# UNITED STATES PATENT AND TRADEMARK OFFICE

APPLICATION NO.	FILING DATE	FIRST NAMED INVENTOR	ATTORNEY DOCKET NO.	CONFIRMATION NO.
10/532,342	06/09/2005	Tadashi Fukuhara	SNK-001-US	1639
21254	7590	02/14/2008		
MCGINN INTELLECTUAL PROPERTY LAW GROUP, PLLC			EXAMINER	
8321 OLD COURTHOUSE ROAD			KENNY, DANIEL J	
SUITE 200			ART UNIT	PAPER NUMBER
VIENNA, VA 22182-3817			3633	
		MAIL DATE	DELIVERY MODE	
		02/14/2008	PAPER

<b>Office Action Summary</b>	<b>Application No.</b>	<b>Applicant(s)</b>
	10/532,342	FUKUHARA ET AL.
	<b>Examiner</b> DANIEL KENNY	Art Unit 3633

**DETAILED ACTION**

Annotated Fig. 5 (U.S. Pat. 5,535,567)

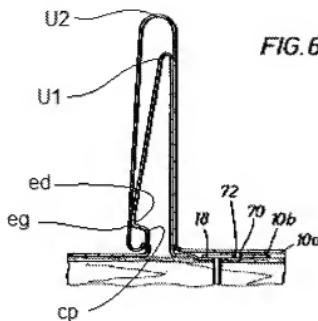
Cahoon discloses a metal roof comprising:

**Claim 1** – a metal roof cover panel wherein the panel includes:

a mainsheet;

an overlapped part (26) extending approximately along a longitudinally edge of the mainsheet, the overlapped part folded back into an almost hairpin-like cross-sectional shape with an engaged part (ed) formed therein;

an engaging part (eg) formed on the opposite longitudinal edge of the main sheet, the engaging part engaging and fastened with the engaged part;

an overlapping part (24) overlapping the overlapped part;

and a substantially flat fastening part (10b) adjacent the overlapped part, a portion of the main sheet near the overlapping part being located on the fastening part of an adjacent construction sheet, and the overlapping part overlapped with the overlapped part.

**Claim 3** – The engaged part is formed on the overlapped part, the engaging part is formed on the overlapping part, and the engaging part is engaged with the engaged part (see annotated Fig. 5).
